# SKF Product Information

## VKPC 81215 – OE/SKF Evoluzione disegno pompa acqua

SEAT Arosa, Cordoba, Ibiza II/III 1.0, 1.4  
VW Caddy II, Polo, Lupo 1.0, 1.4

OE Nb: 030 121 008 C, 030 121 005 S

### VKPC 81215

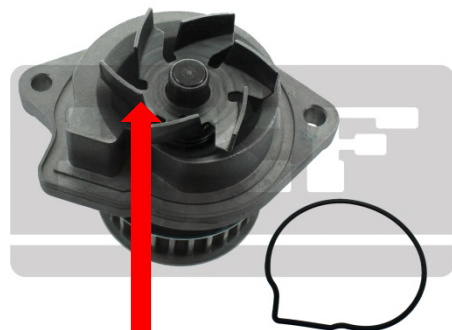
In seguito alla variazione del disegno OE, SKF ha variato il disegno della pompa acqua contenuta nel kit VKPC 81215 dal batch code 064N. La variazione del disegno riguarda il materiale della girante e della guarnizione. Tale variazione ha un impatto anche sui kit distribuzione completi di pompa acqua: VKMC 01106-1 e VKMC 01107.

- Girante in plastica
- Guarnizione di carta

Vecchio disegno

- Girante in acciaio
- Guarnizione in gomma

Nuovo disegno
